New Jersey Turnpike Authority

Document Change Announcement

Concrete Collars for Flared End Sections

DCA2026SD-03

FLARED END SECTIONS FOR HDPE PIPES

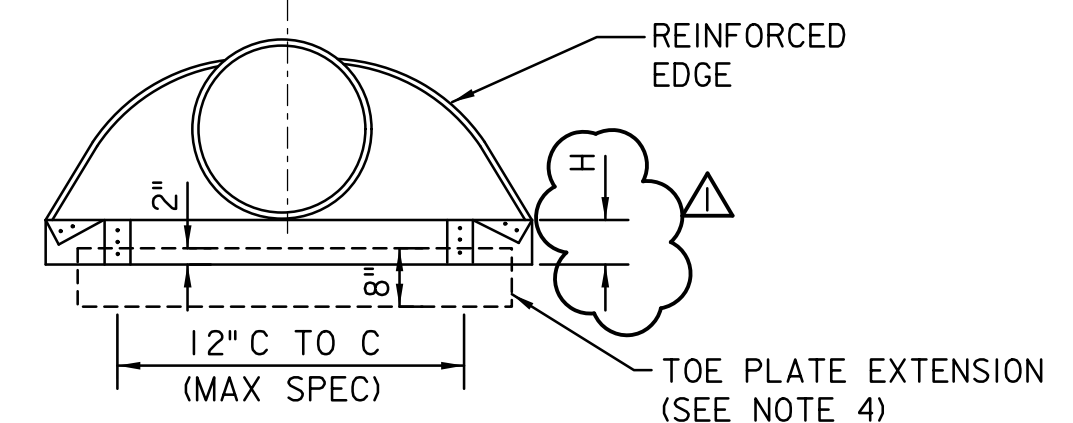
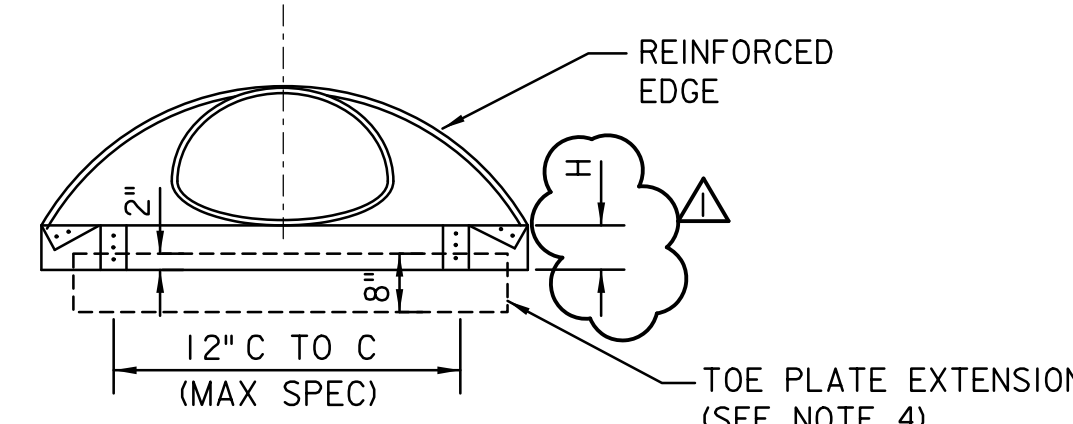
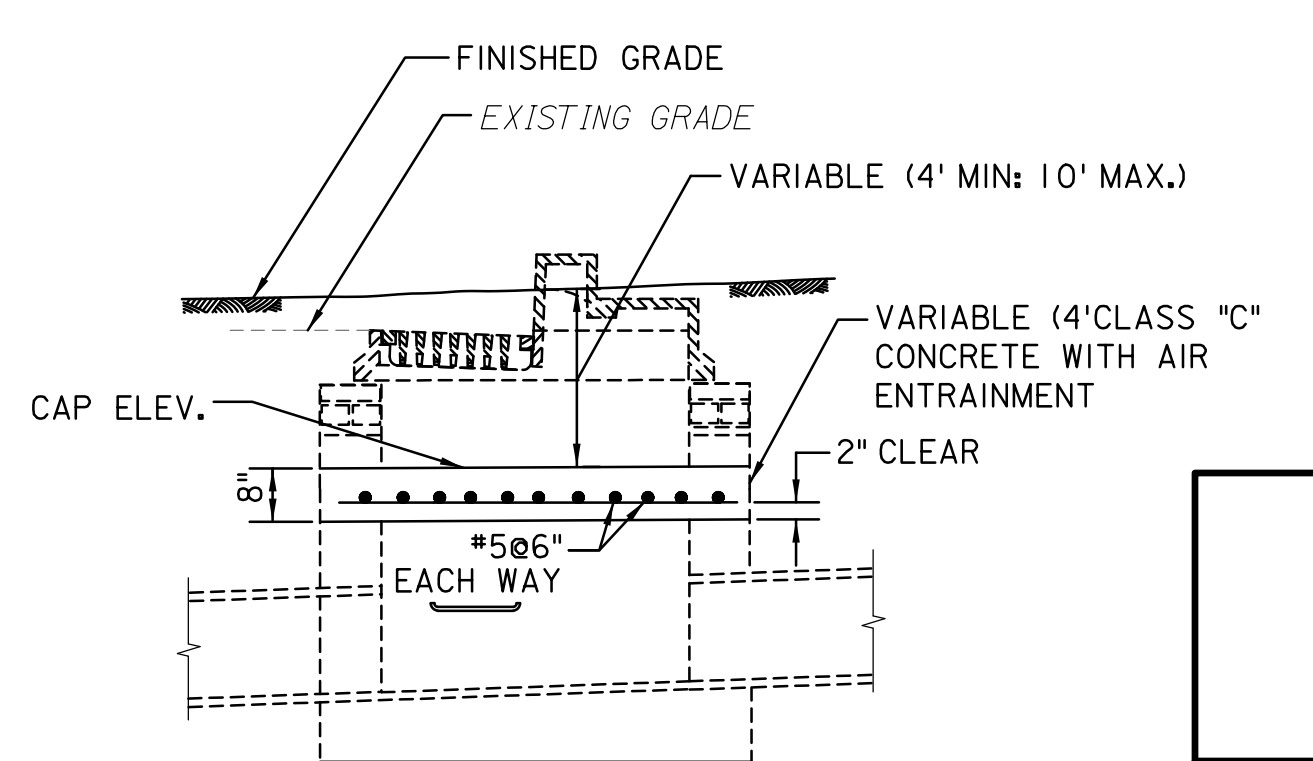
This DCA adds a concrete collar to be installed at existing and proposed flared end sections.

REV.	DESCRIPTION	DATE
1	UPDATED FOR HDPE PIPE AND CONCRETE COLLAR	03/26
0	ORIGINAL DRAWING	04/09

FLARED END SECTION
CONCRETE COLLAR

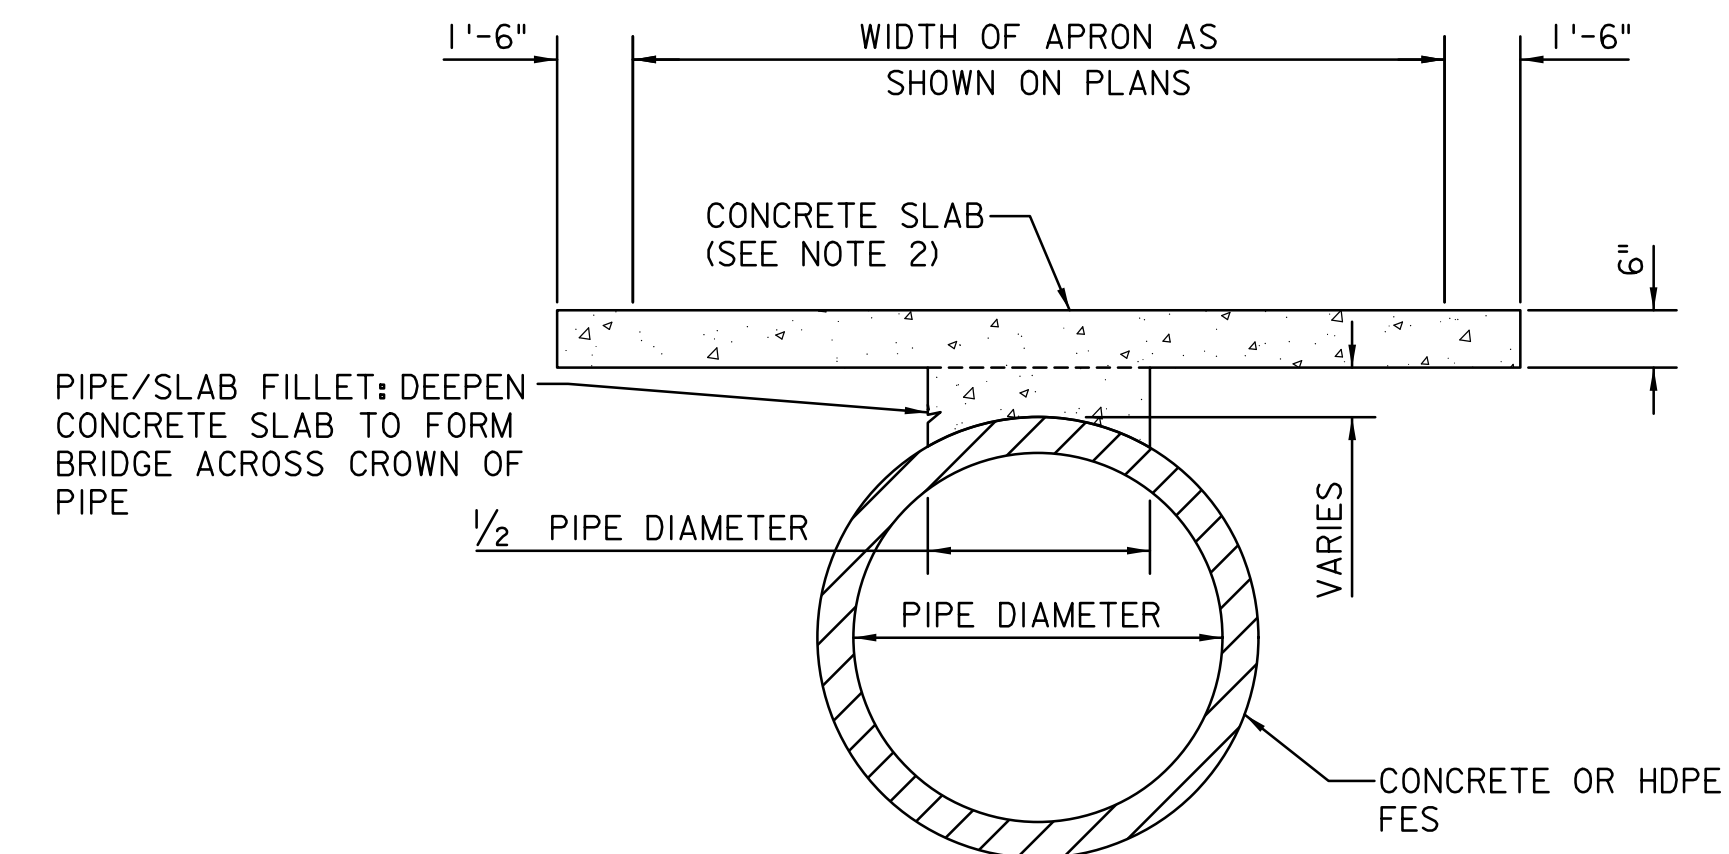
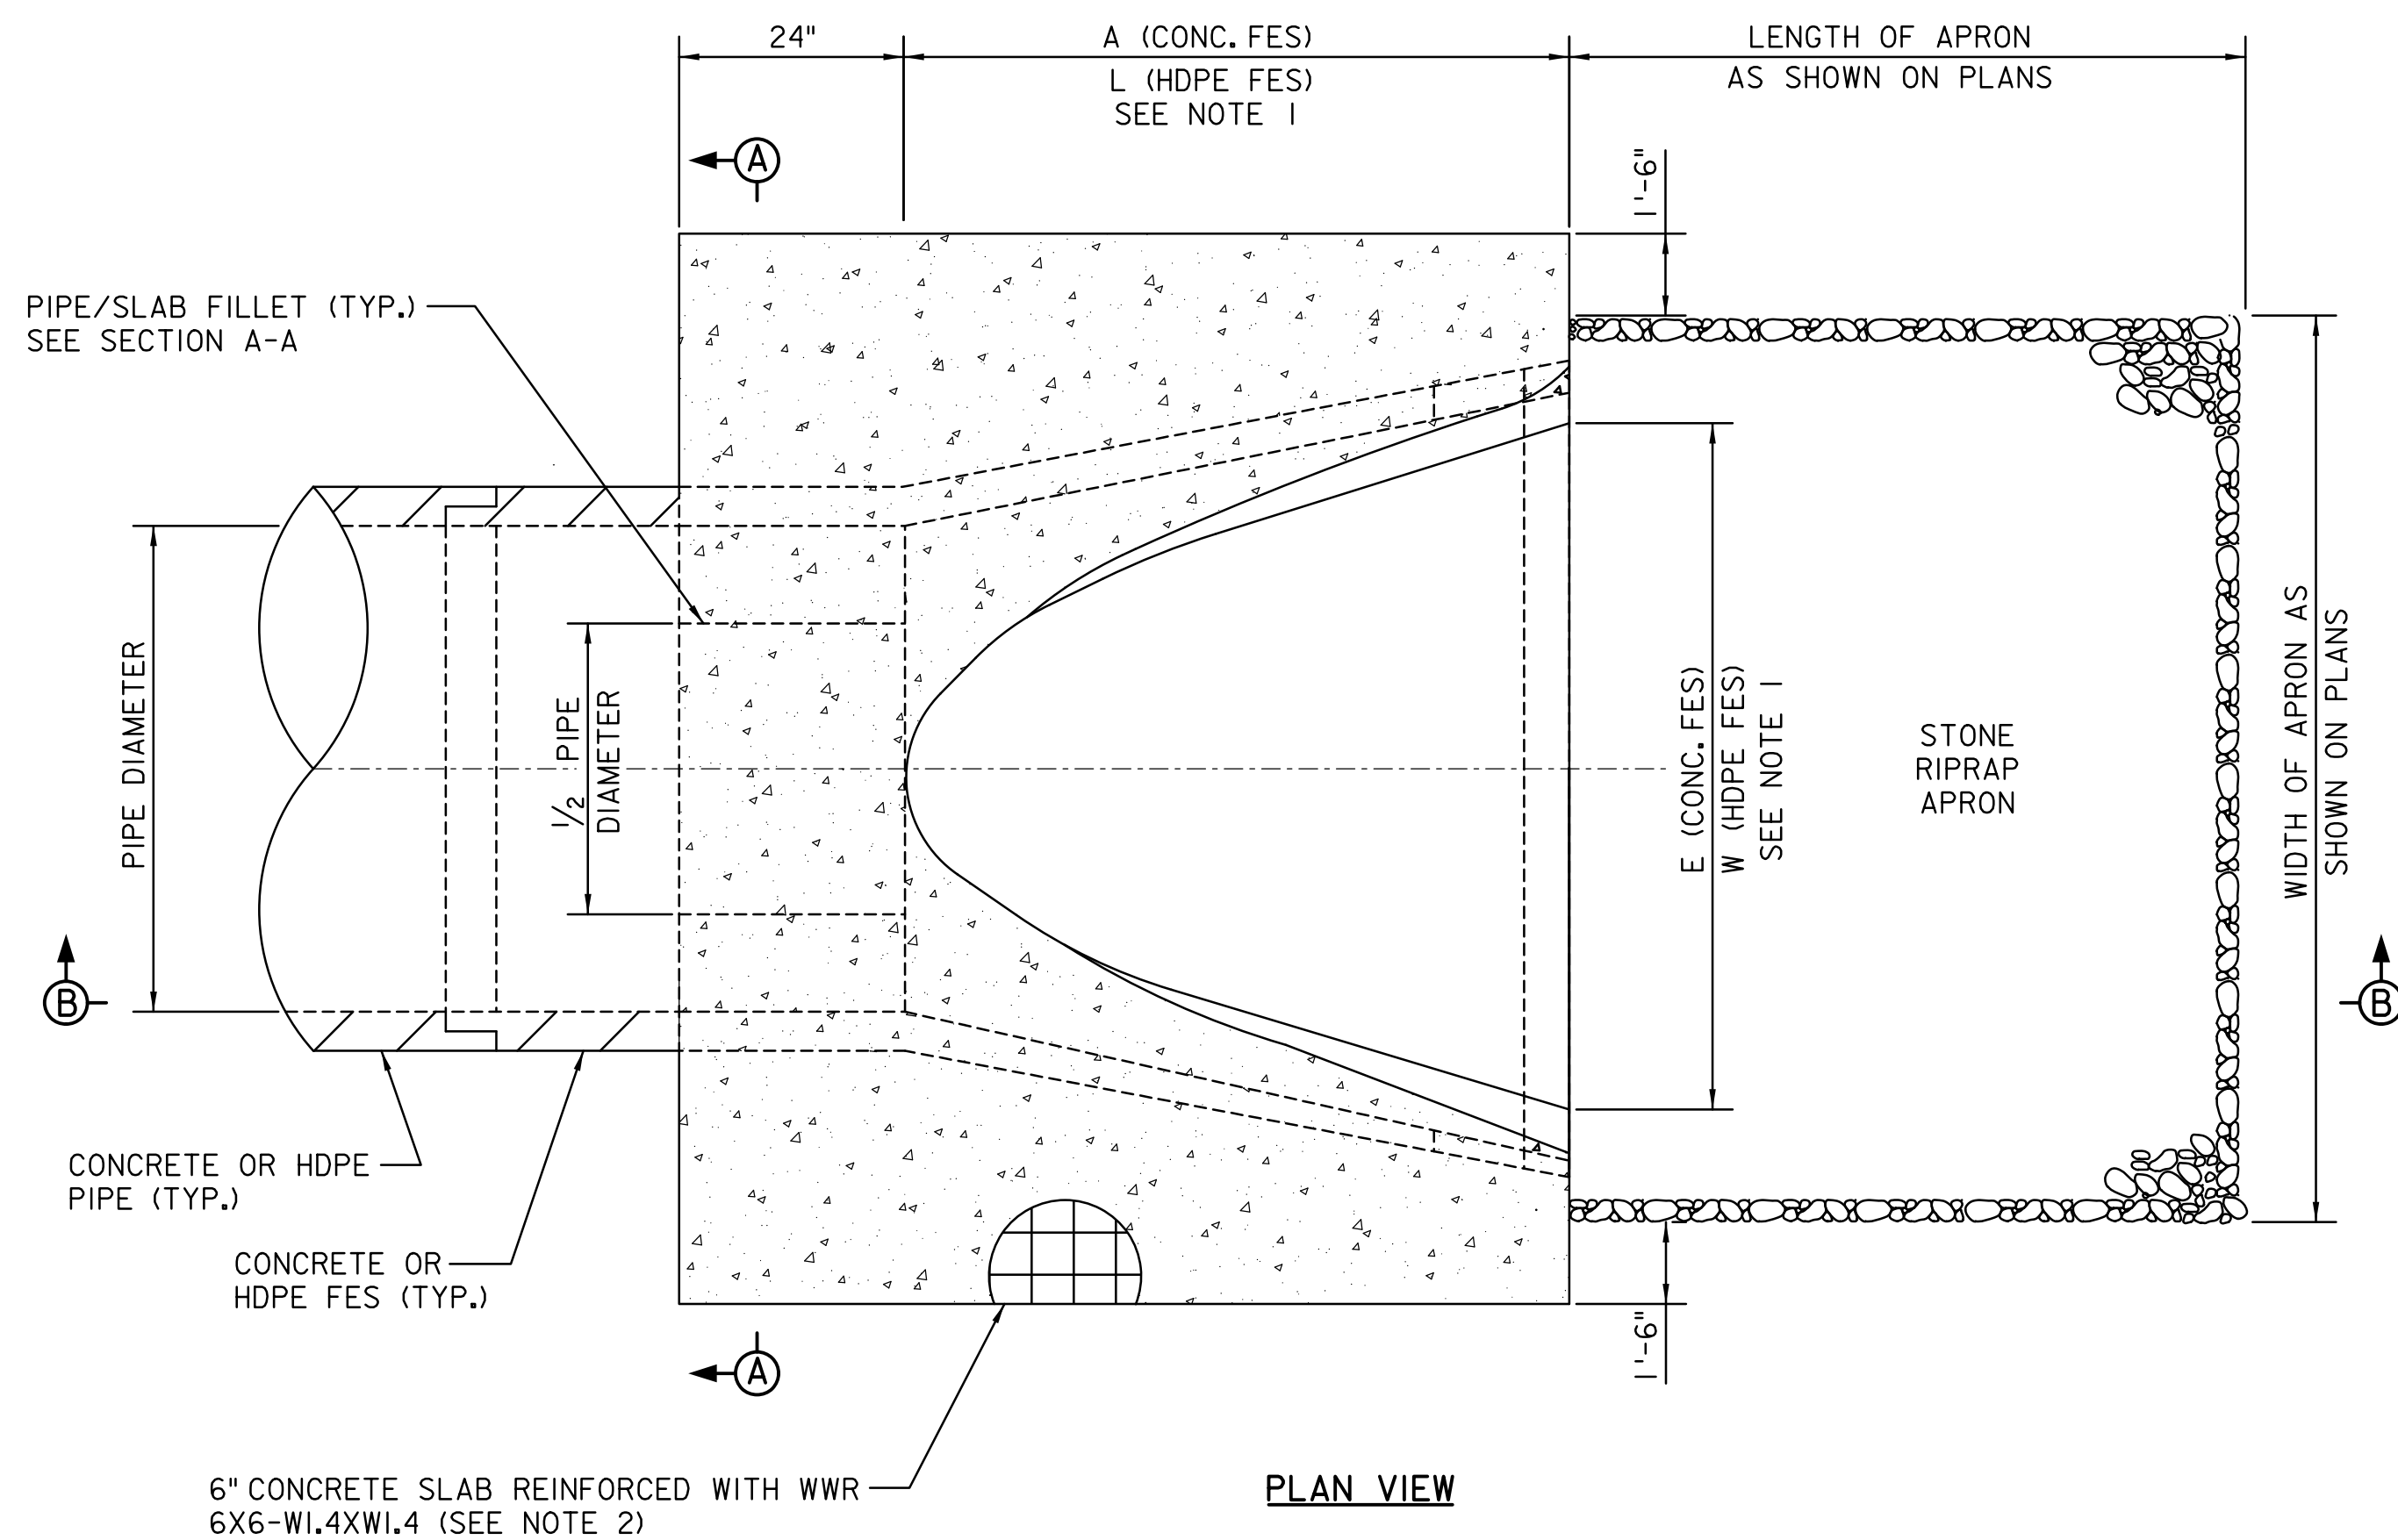
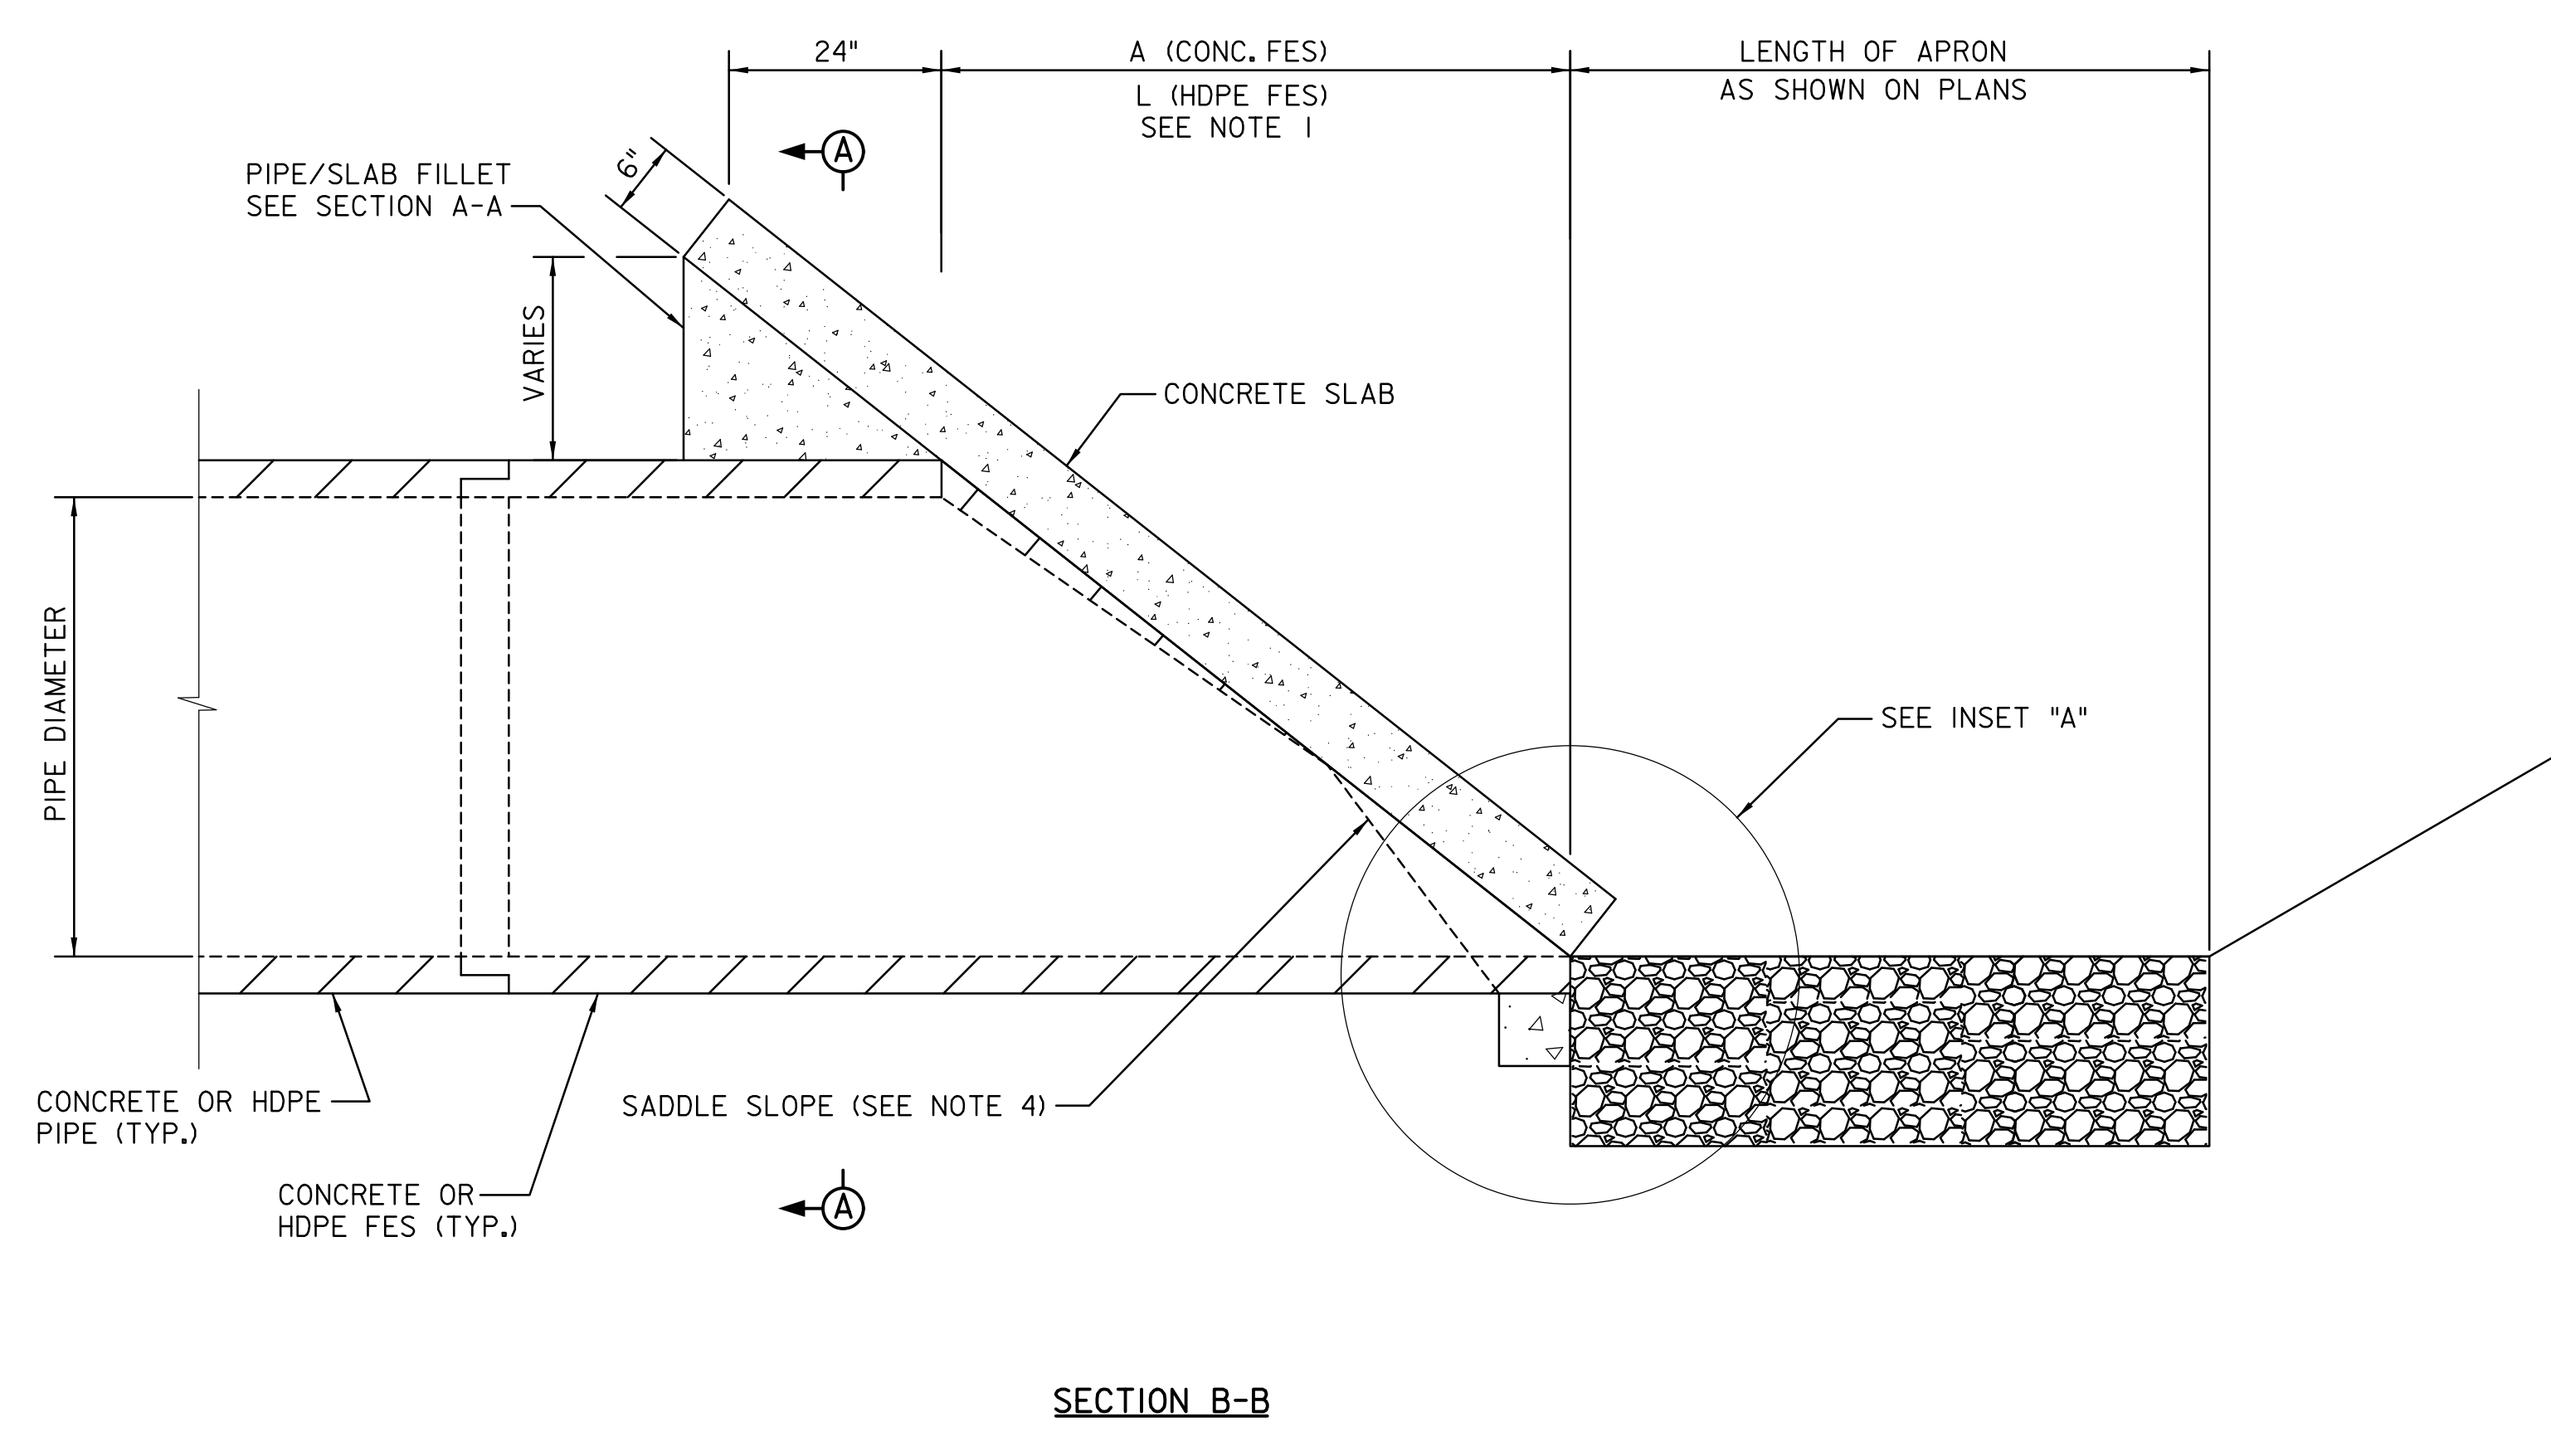
Drawing DR-4A Flared End Section Concrete Collar

1. WORK THIS DRAWING WITH STANDARD DRAWING DR-4 FOR CONCRETE AND HDPE FLARED END SECTIONS. REFER TO TABLES ON STANDARD DRAWING DR-4 FOR DIMENSIONS.
2. CLASS B CONCRETE CAST-IN-PLACE REINFORCED SLABS ARE REQUIRED FOR ALL PIPE DIAMETERS.
3. STONE RIPRAP APRONS ARE REQUIRED WITH FLARED END SECTIONS FOR ALL PIPE DIAMETERS.
4. SLOPE TO CENTERLINE OF PIPE LESS THAN OR EQUAL TO 18" DIAMETER. SLOPE 1:1 FOR PIPES LARGER THAN 18" DIAMETER.
5. FOR INSTALLATION OF CONCRETE COLLARS AT EXISTING FLARED END SECTIONS TO REMAIN, THE 6"X6" CONCRETE SUPPORT SHALL BE ELIMINATED WITHIN THE LIMITS OF THE EXISTING END SECTION.
6. CONCRETE COLLAR TO BE PAID FOR AS INCIDENTAL CONCRETE.
